Special Council Assessment Panel Agenda & Reports

6 March 2024

Application for removal of significant tree and variation of existing Planning Consent.

AERIAL PHOTOGRAPH OF THE PMSC IN 1979 WHICH DOES NOT SHOW TREE 2 TO THE EAST OF THE MAIN POOL

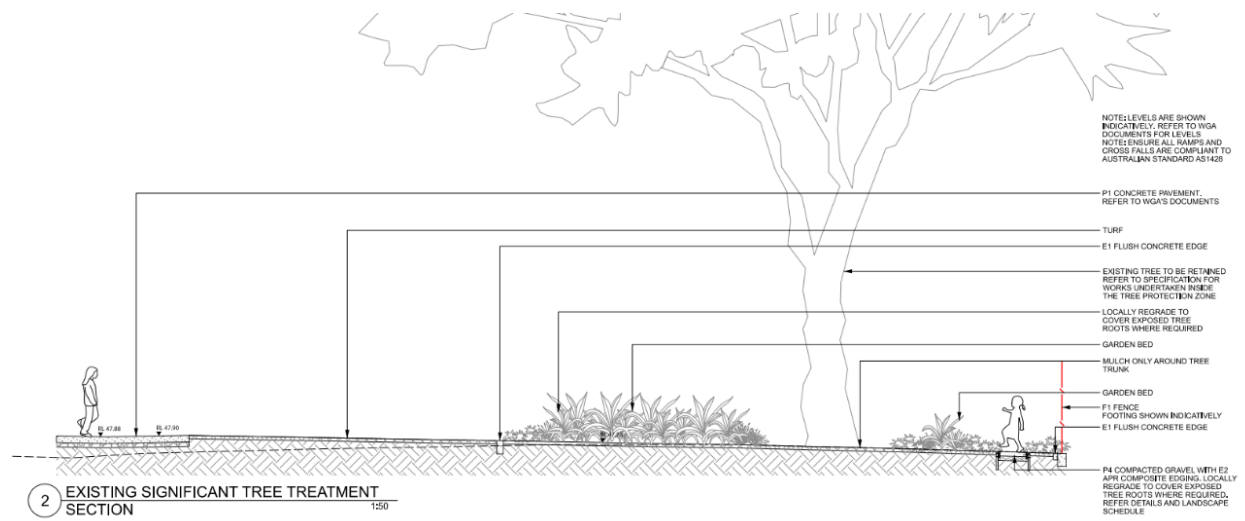
Tree 2 is not a local indigenous or remnant species. It was planted post 1979, as attested by the attached aerial photo of the site from that year and therefore definitely planted during the tenure of the existing pool facility which was built in 1968 and from the evidence of the aerial photography, it is no more than 44 years old.

CROSS SECTION OF EASTERN SIDE OF POOL IF TREE 2 IS RETAINED – slope away from pool shown

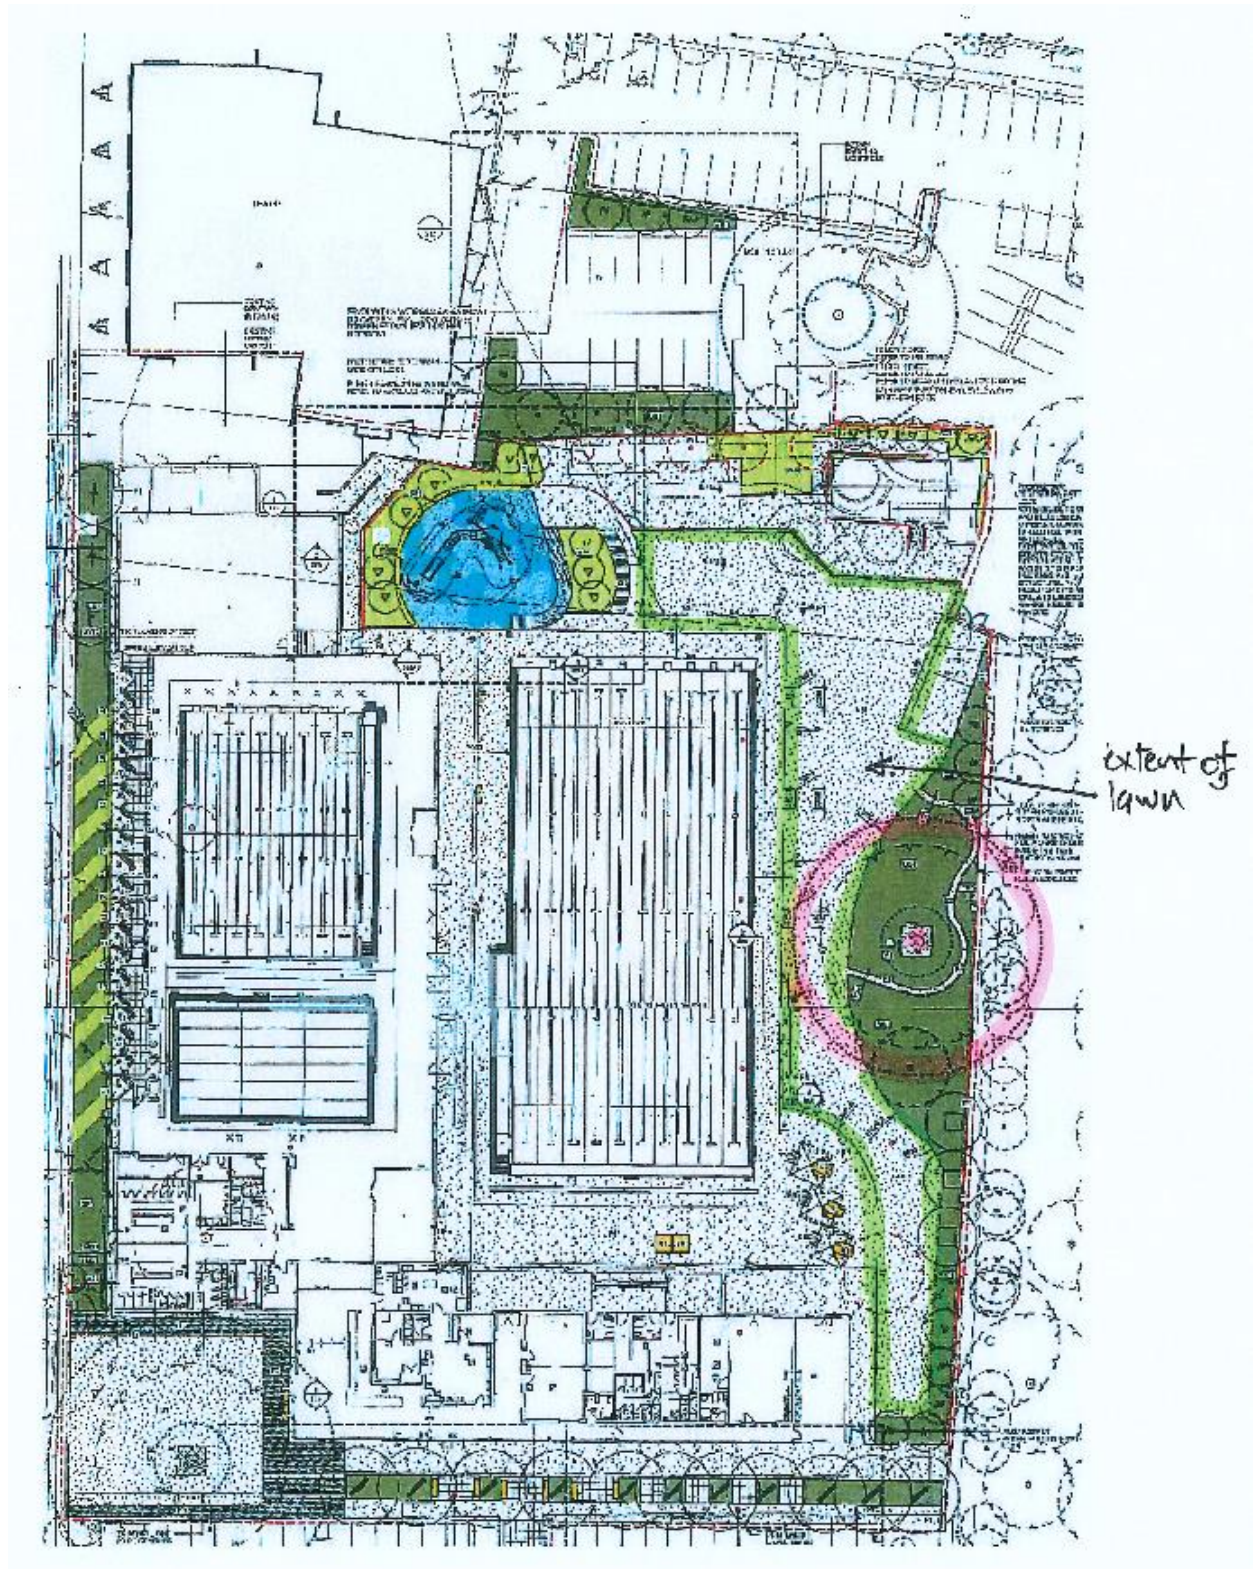
With the fear for public safety regarding limb drop, significant exclusion zones around Tree 2 were established in the attached landscape plan and the resultant mulched area significantly reduces the lawned area available to the community for recreation and picnic space.

EXISTING LANDSCAPE PLAN OF THE EASTERN SIDE OF THE OUTDOOR POOL AREA

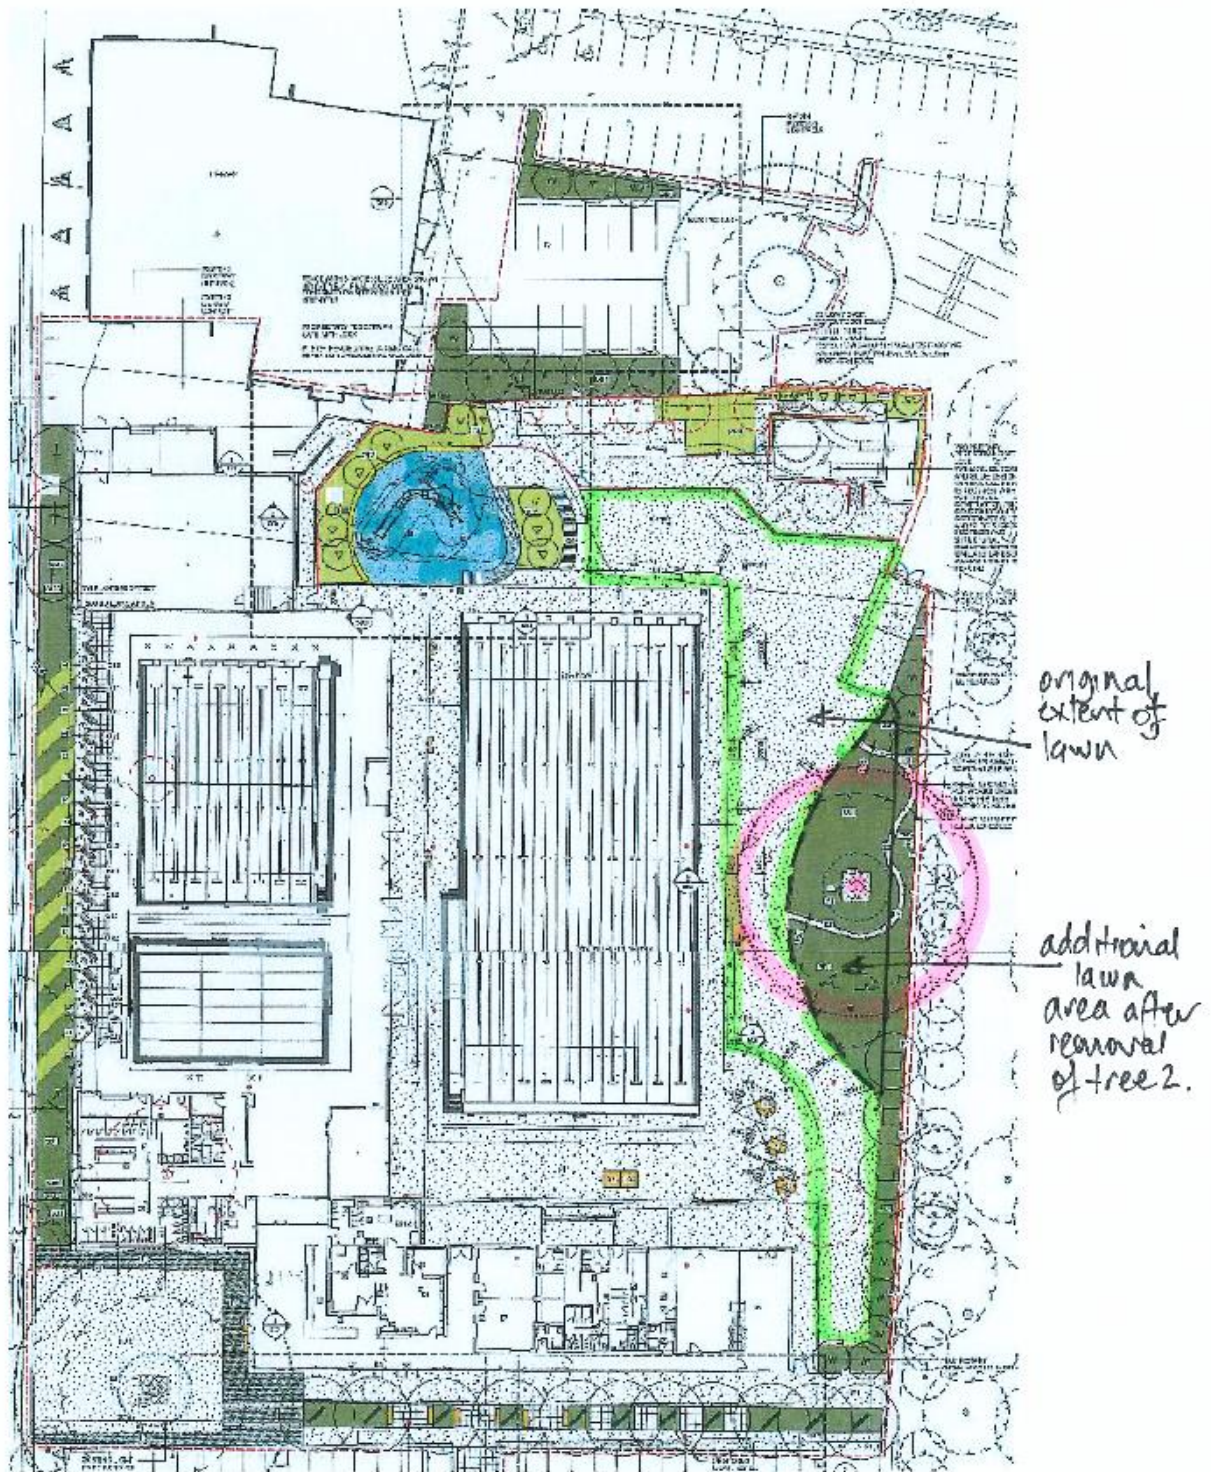
The attached plans indicate how landscaping and tree planting is currently proposed, and how it could be undertaken should the Tree 2 be removed. Trees with non-invasive roots would be planted closer to the outdoor pool to provide afternoon shade to the area between the eastern side of the pool concourse and the eastern site boundary which would be planted with lawn to provide as much open and usable space as possible for the patrons.

Tree 2

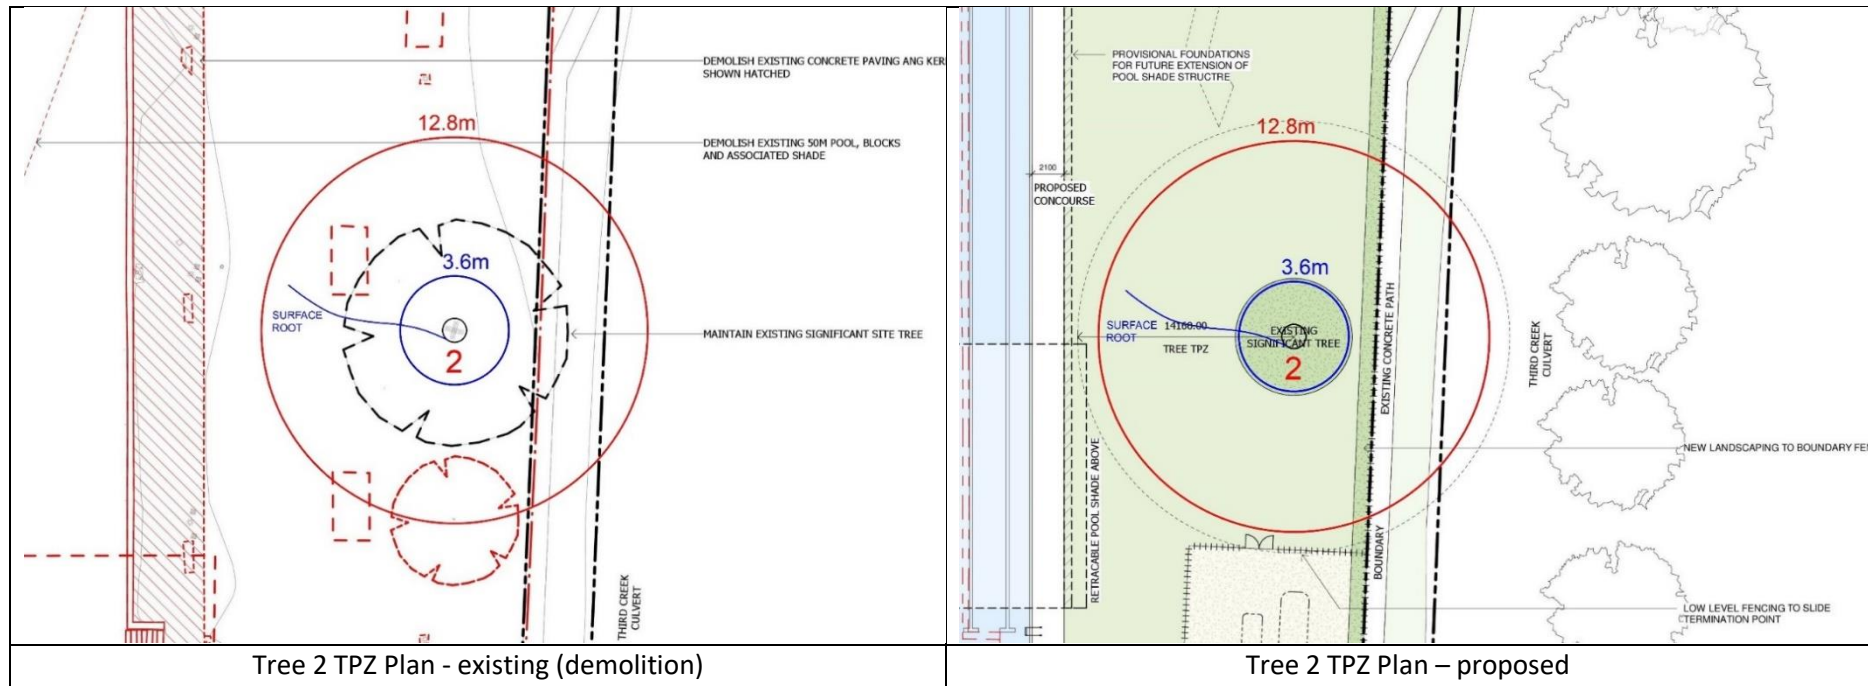
Trees 2 & 3 are mature specimens of *Eucalyptus grandis* (flooded gum or rose gum) a tall forest tree from the high rainfall coastal belt of eastern Australia. In habitat it can growing 50m+. It is usually seen with an ascending, almost excurrent form, with a single leading trunk and angled lateral branches. Where water is in good supply it grows very quickly. Its aesthetic can reduce during drought conditions. It was once often planted as a shade tree for parks. It is not generally suited to confined spaces such as small suburban gardens and is rarely seen for sale nowadays. The species is relatively shallow rooted and when grown in lawn areas it tends to develop substantial surface roots which later present turf management problems and potential trip hazards. Typical of numerous types of gums, large mature trees can be difficult to reduce in size with any degree of subtlety.

Attachment 9 – Alternate Landscape Plan

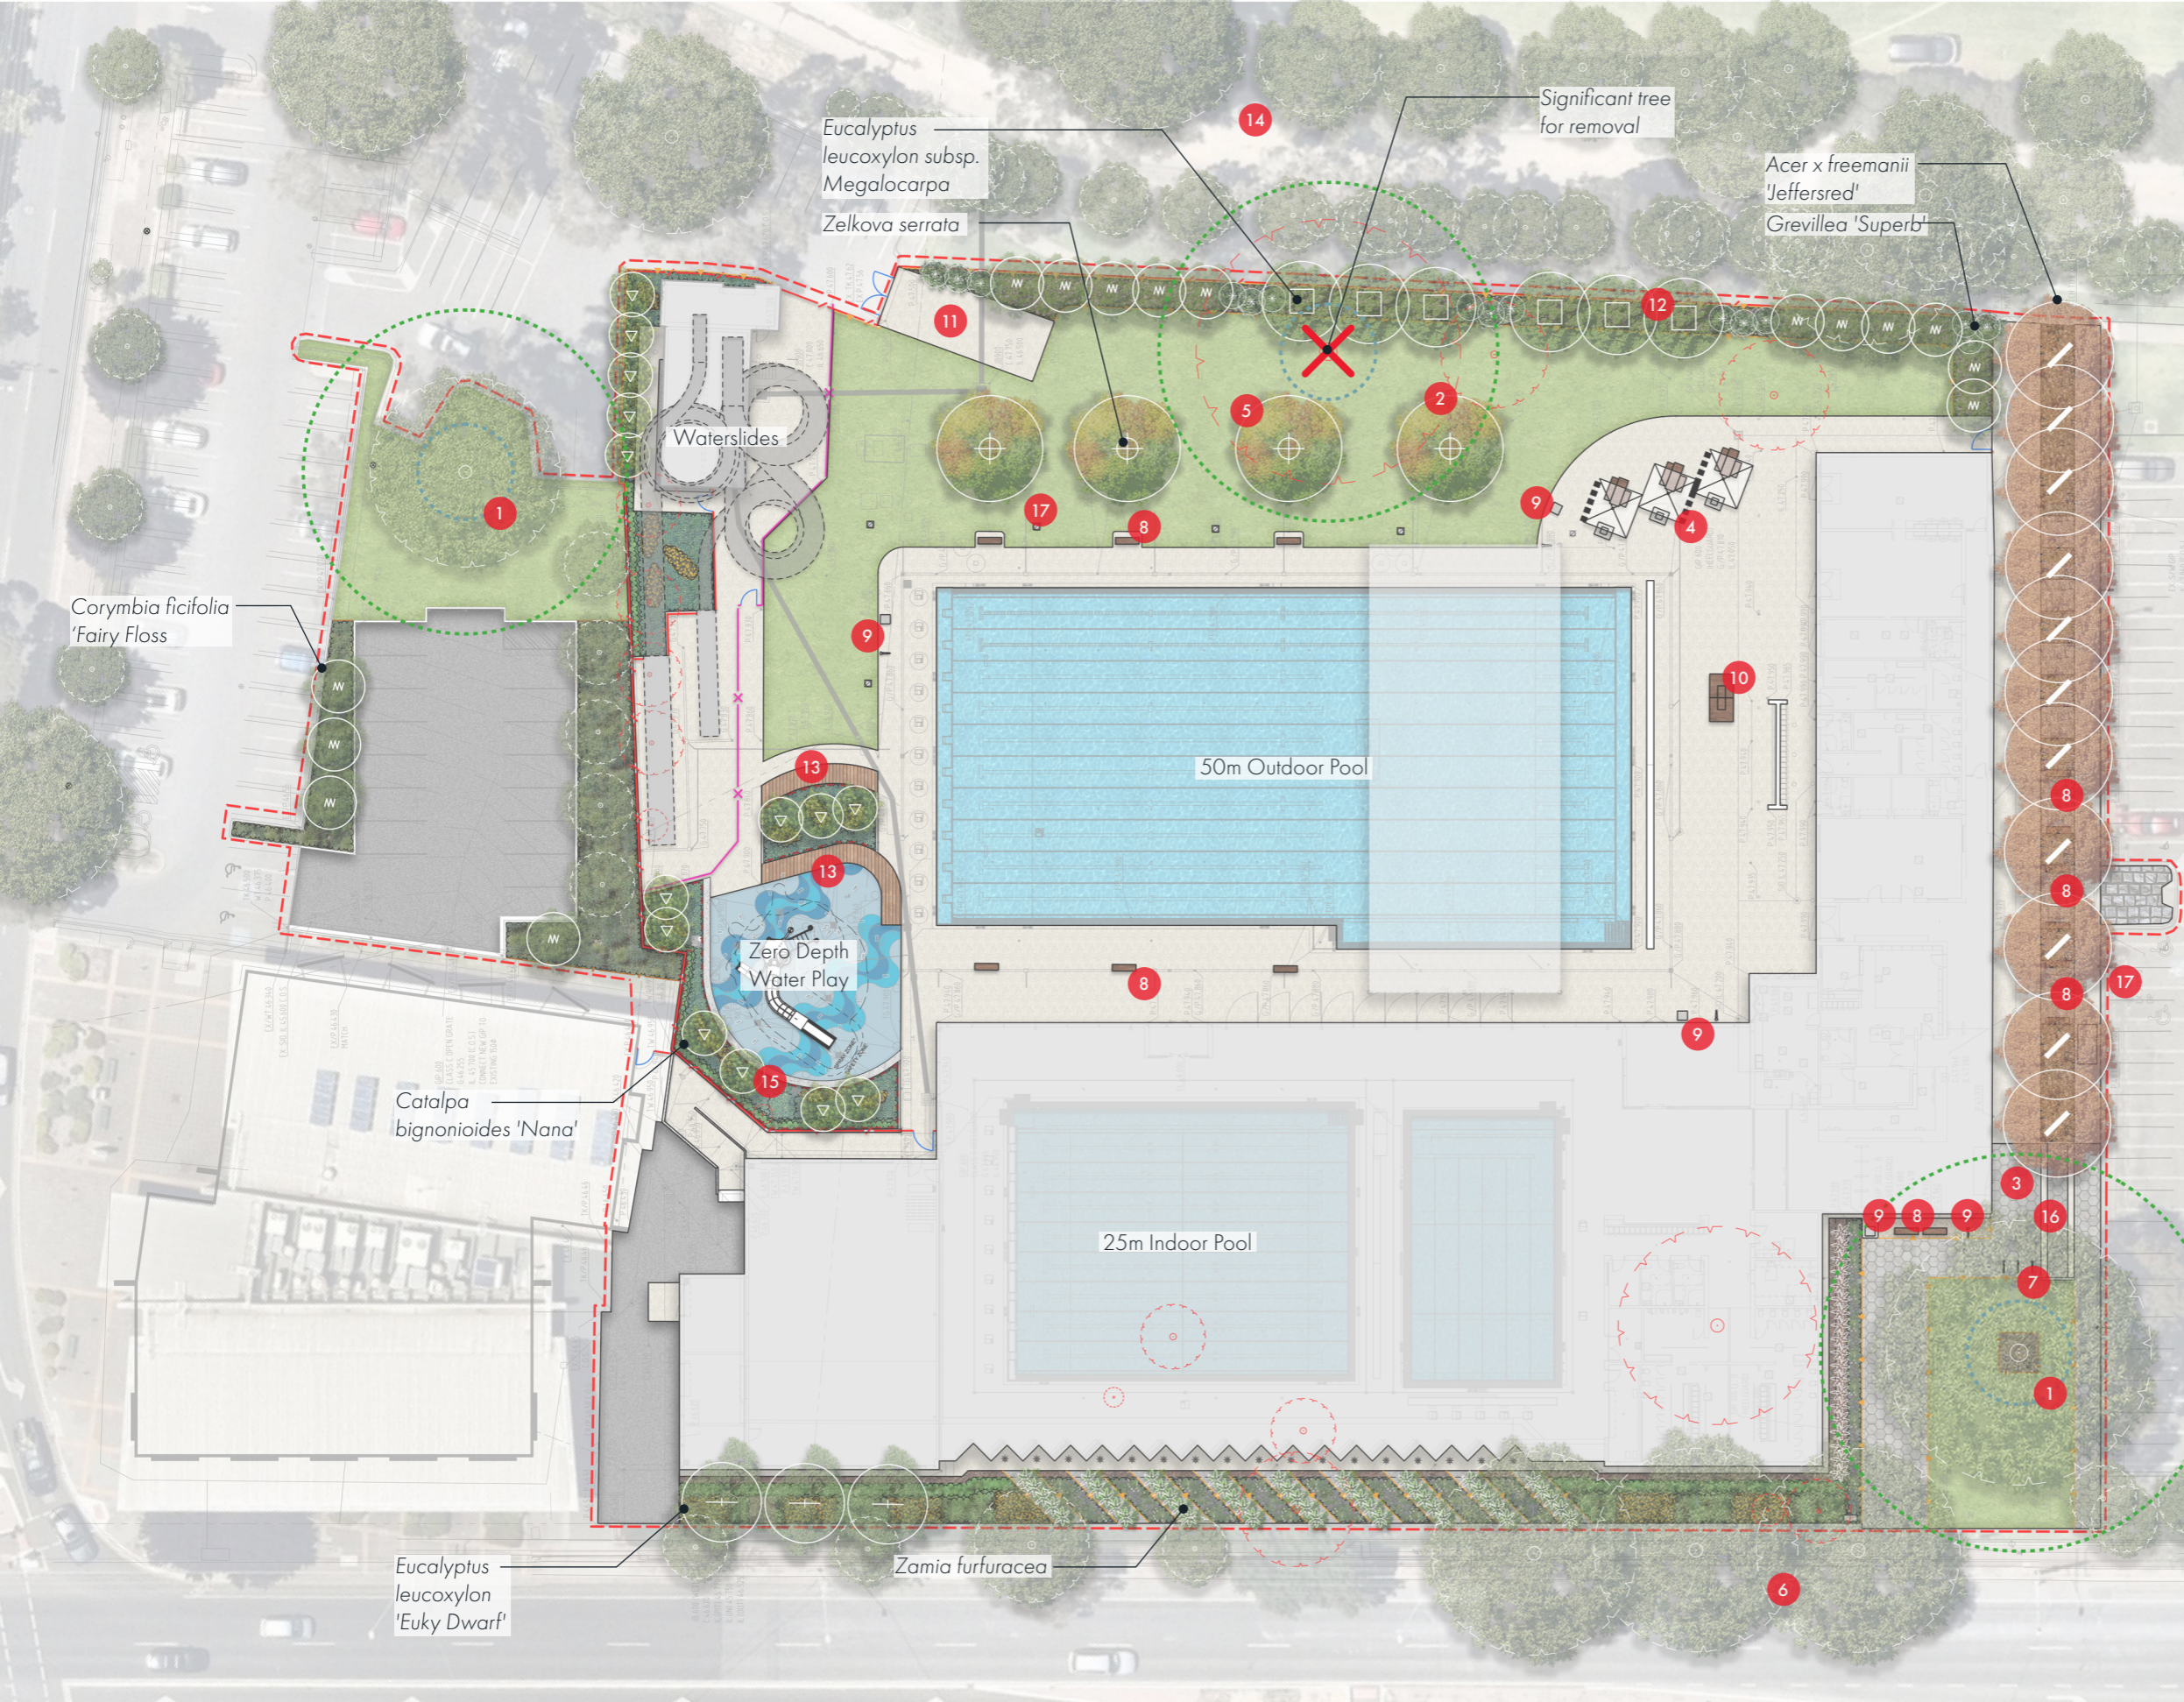
To offset the loss of shade cover and habitat and biodiversity value that the subject tree provides, the Applicant has proposed a new landscaping plan (see p 105 **Attachment 1**) – and the Panel will recall that a detailed landscaping plan was recommended to be required by way of a Reserved Matter the last time this item was presented for your consideration. This landscaping plan provides for an additional ten (10) trees being planted on the site and a more usable lawn area for visitors. The Applicant has confirmed that any change to the landscaping plan does not require Council endorsement nor a variation to the existing LGIPP Grant Deed. This landscaping plan goes beyond what is required by regulation 59(1)(b) of the *Planning, Development and Infrastructure (General) Regulations* – that is, to plant just 3 replacement trees – and is consequently considered an acceptable response.

All areas of landscaping demonstrated on the herein approved Landscape Plan (Drawing No: 321-0359-00-L-02-DR01, dated 22.02.2024) shall be planted within the next available planting season after the completion of the development to the reasonable satisfaction of the Assessment Manager and such plants, as well as any existing plants which are shown to be retained, shall be nurtured and maintained in good health and condition at all times, with any diseased or dying plants being replaced, to the reasonable satisfaction of the Assessment Manager or its delegate.
